2008 Touring Fuel Filter Shell Recall 0135

Figure 4-12. Fuel Filter Assembly

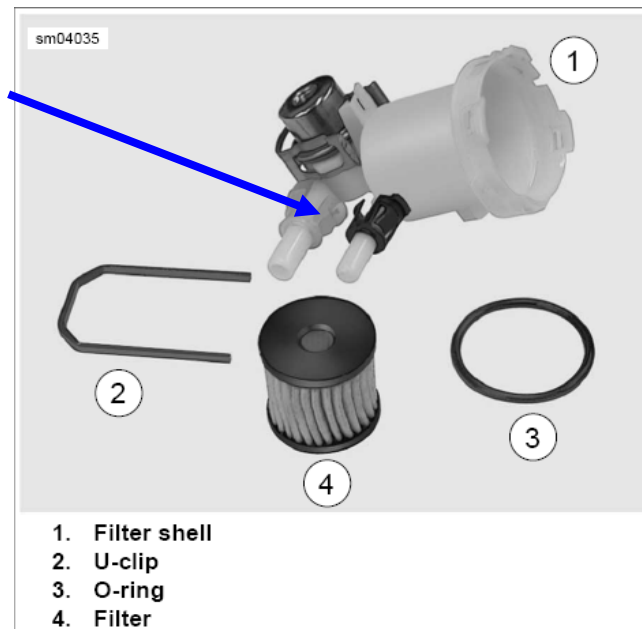
The recall requires you to reuse the fuel line retainers that secure the hoses to the filter shell. Use care to remove the retainer from the old filter shell and insert the retainer into the correct fuel line. The fuel line and retainer are then connected to the new fuel filter shell fitting until it clicks into position. A firm pull test is recommended to verify a positive engagement. Should the line become disconnected from the filter shell the line may leak and the motorcycle will display low fuel pressure symptoms. Please ensure all your service technicians understand the importance of double checking these connections.
